Access Compliance Report Public Rights-of-Way (Pedestrian Signals)

Main Street: **NEWPORT_AVE** Cross Street: **FOOTHILL_BLVD** Location: **SE**

ADA ID: **SGAT211018091056** Signal Type: **One Push Button-Non APS** Overall Compliance: **No** Severity Scores: **BTN 1: 35** **BTN 2: N/A** **No BTN: N/A**

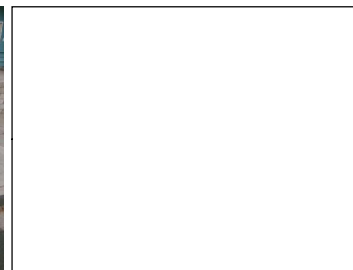
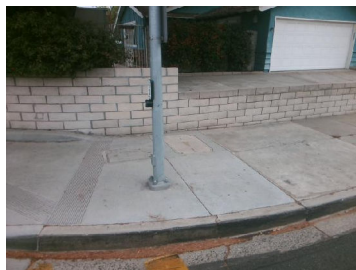
OC Std/PROW: **R404.2, MUTCD 4e.08**

Possible Solutions: Replace Signal Push Button With APS Button. Remove and Replace Clear Space.
